Re: Implementation of the Alternative Energy Portfolio Standards Act of
2004: Standards for the Participation of Demand Side Management
Resources – Technical Reference Manual Update
Docket No. M-00051865

**COMMENTS OF METROPOLITAN EDISON COMPANY,
PENNSYLVANIA ELECTRIC COMPANY
AND PENNSYLVANIA POWER COMPANY TO THE 2011 TRM ANNUAL UPDATE**

Source: NMR Group Inc, "Final CFL Modeling Report" (2010)

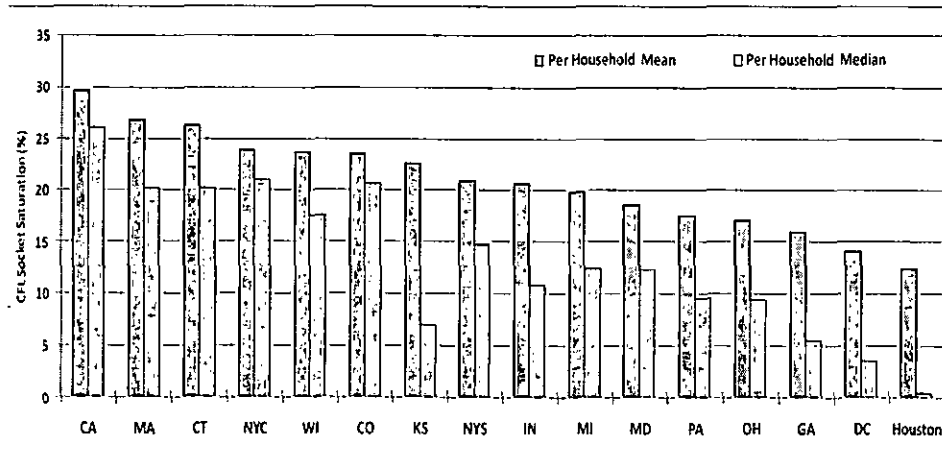
The following chart is from an NMR Group, Inc. Survey and shows the “Socket Saturation” survey results (i.e. the percentage of light sockets with CFLs) state by state. This survey clearly demonstrates the significant differences between California and Pennsylvania markets. California has a socket saturation mean near 30% with a median over 26%, while Pennsylvania’s saturation mean is roughly 17% with a median under 10%.¹²

CFL socket saturations are as high as 20-30% in some parts of the country, depending on how we measure it.

¹² The median is a better indicator of market participation in CFL programs (which is significantly less than half of California's) but either metric shows that the markets are significantly different.

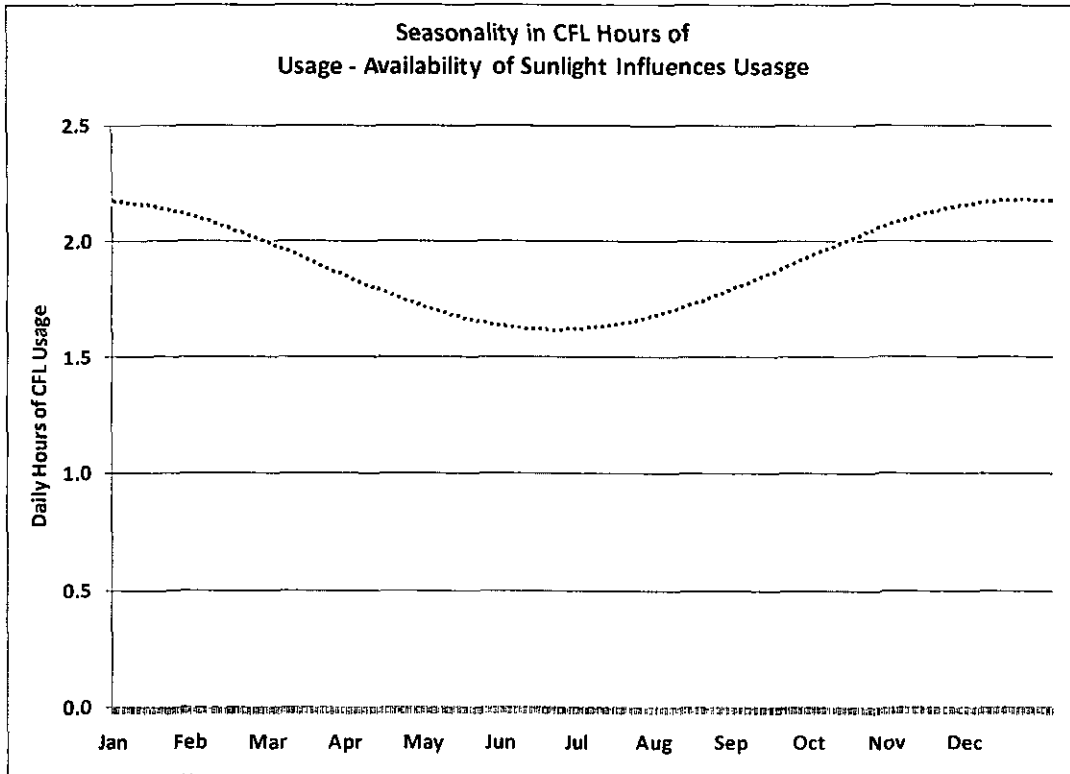
Second, the availability of sunlight also greatly influences CFL HOU, as demonstrated by the seasonal nature of CFL usage. For example, as the following graph adapted from the KEMA Study demonstrates, if the availability of sunlight is lower in Pennsylvania than in California then Pennsylvania CFL usage would be higher – all else held constant. Clearly due to well-established meteorological patterns and home design, the availability of sunlight in Pennsylvania is expected to be lower.
